FINAL ENVIRONMENTAL IMPACT REPORT

Lancaster Landfill and Recycling Facility

County Case No. 93070

December 1997

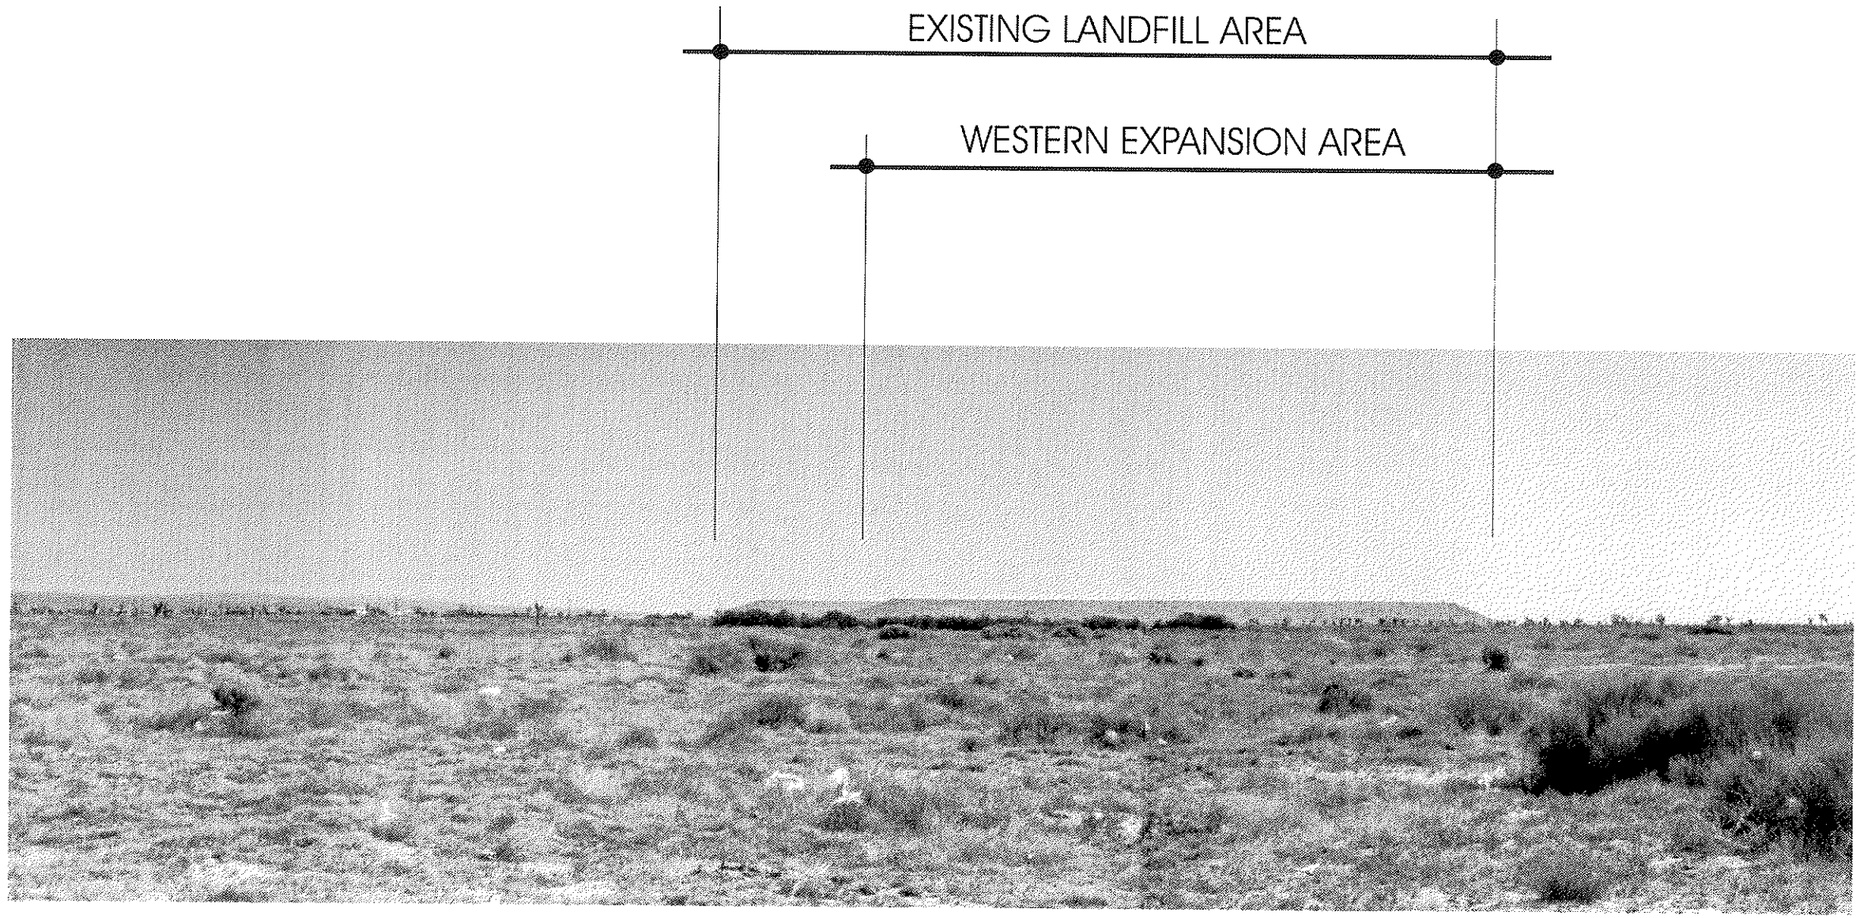
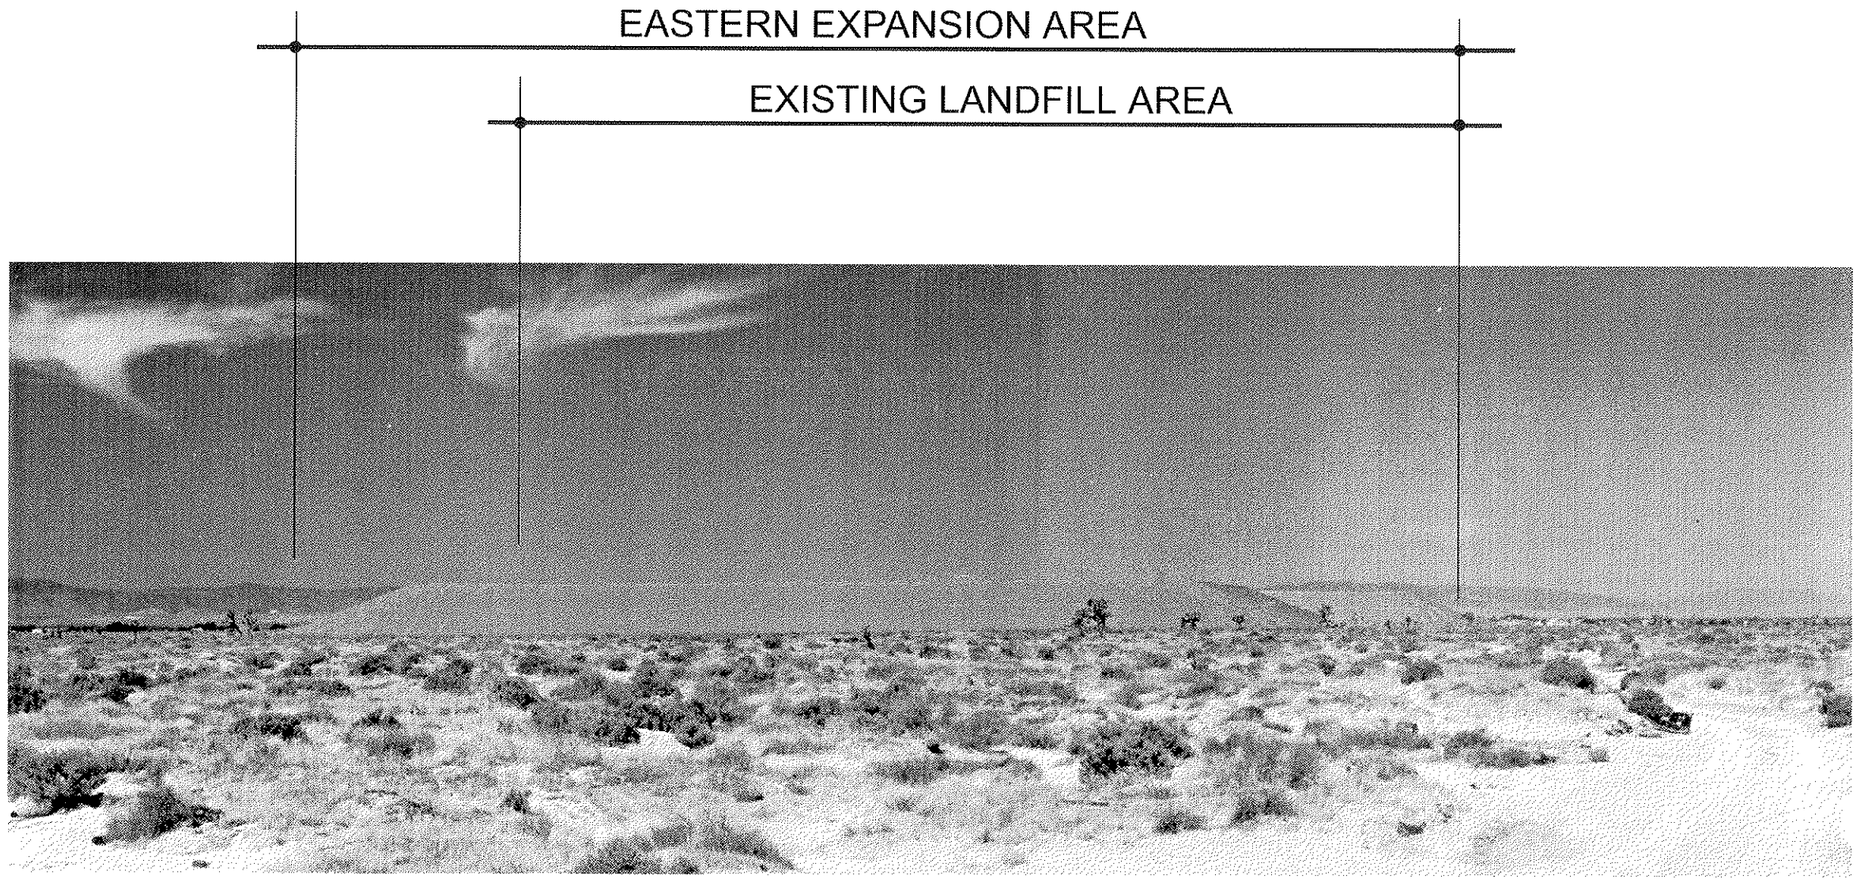
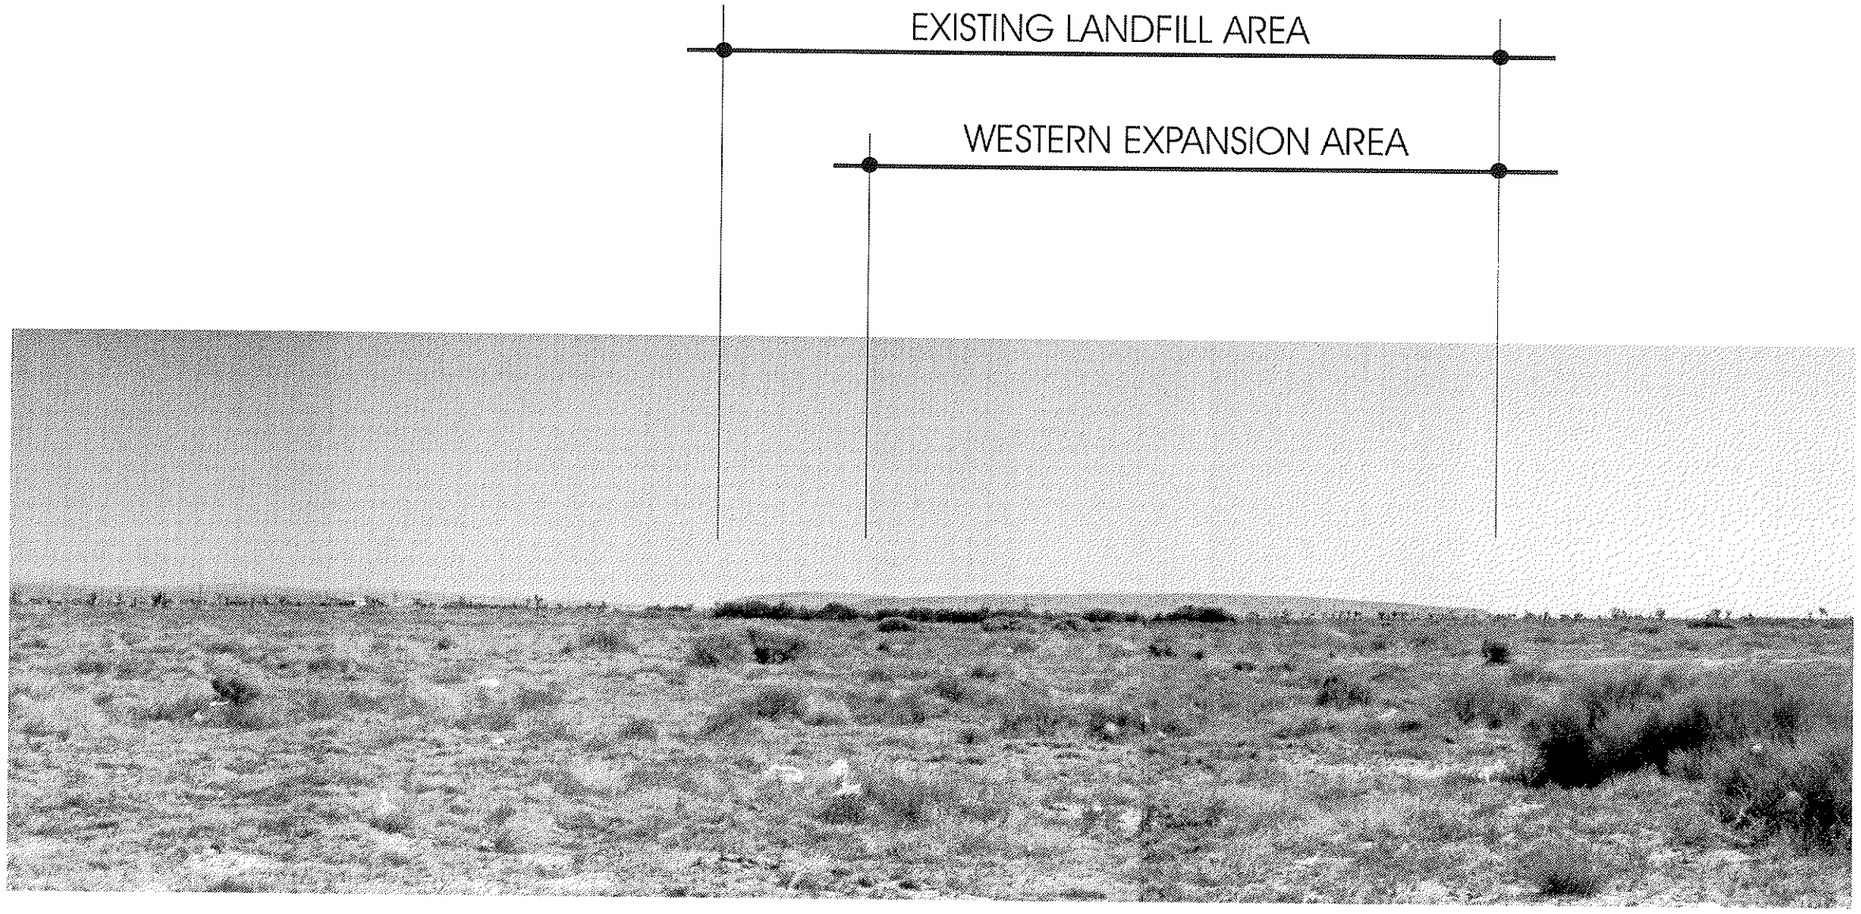
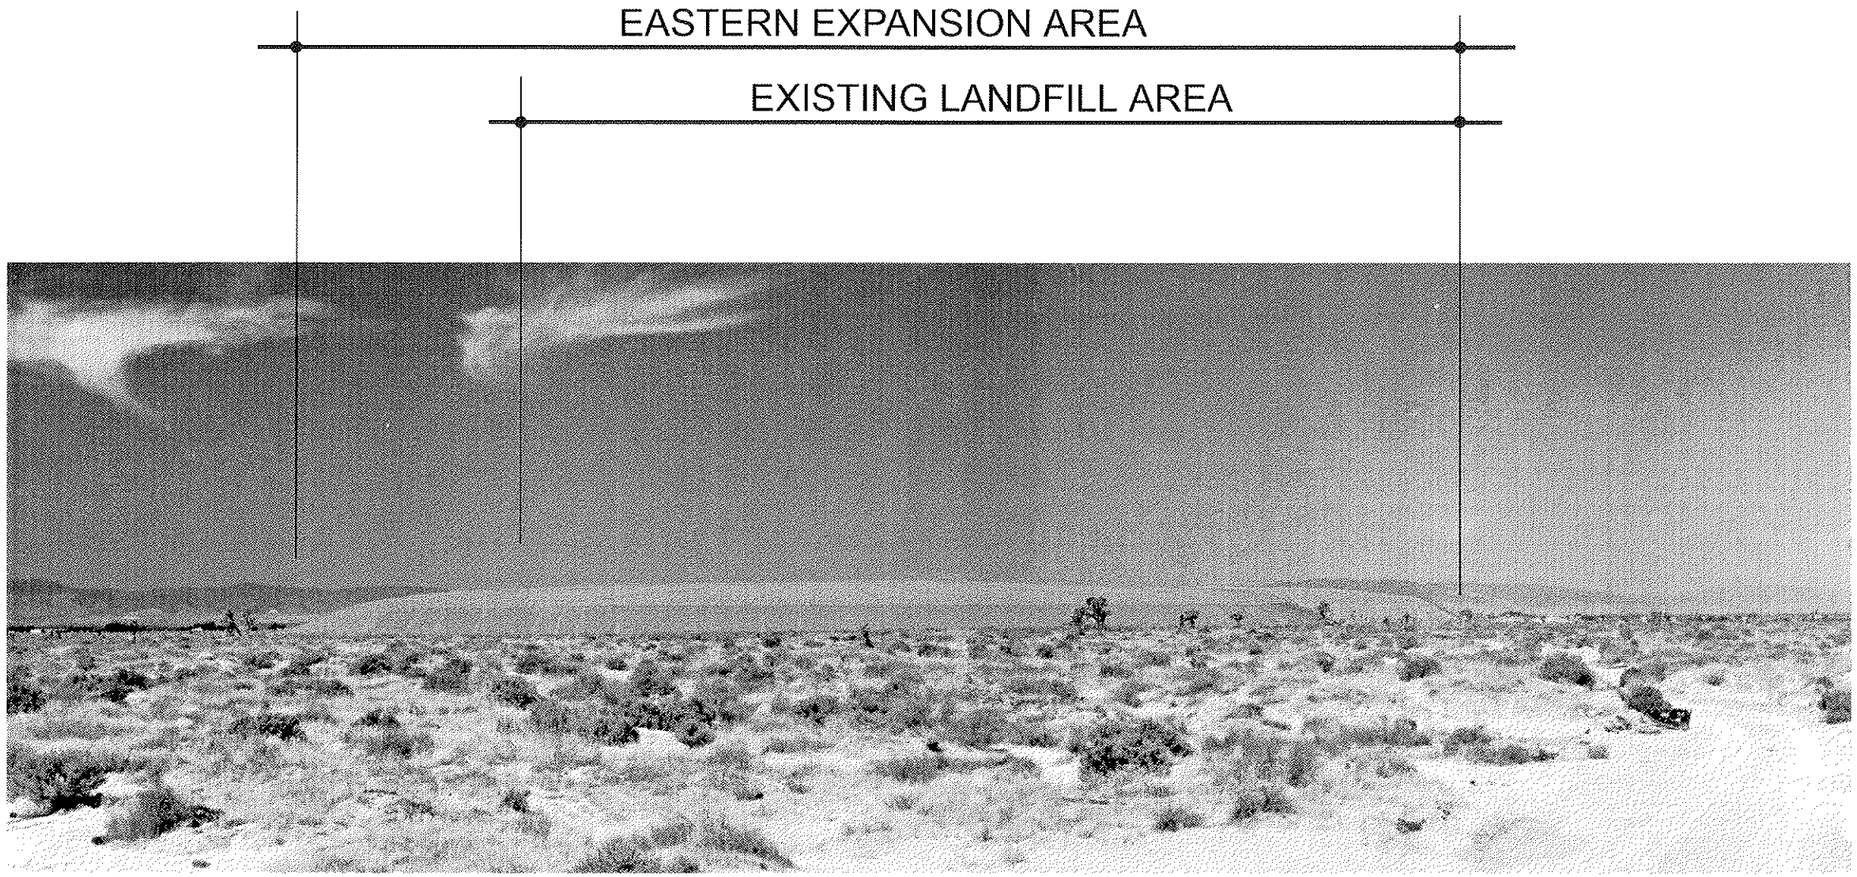
The revised grading plan will reduce the visual impact of the project because it will result in less incremental change to the visual environment than the project evaluated in the Draft EIR primarily due to the reduced height. In addition, the aesthetic form created by the revised grading plan which results in a flat upper deck will blend better with the aesthetic character of the natural, adjacent area which is flat, desert topography than the grading plan assessed in the Draft EIR which had an undulating deck. Figures 4 through 6 illustrate the viewpoints of the revised grading plan and Figures 7 through 9 illustrate the viewpoints of the DEIR grading plan.

The rationale for concluding that the visual impact of the revised grading plan is not significant is the same rationale as that for the alternative evaluated in the Draft EIR. There will be no increase in the visible size of the landfill from the east and west where the existing landfill either obstructs the view of the expansion area in the foreground or buffers the view of the expansion area behind the existing landfill. Views from the north and south will be adversely effected due to the increased landfill area visible but this impact is not considered significant because (1) the increased visible area is not great (2) unique environmental or manmade visual features are not obstructed, (3) the increase will not obstruct views from important public gathering places and (4) views from a County Scenic Highway are not obstructed. The same measures (landscaping, berms) will be implemented to mitigate visual impacts as with the previous grading plan.
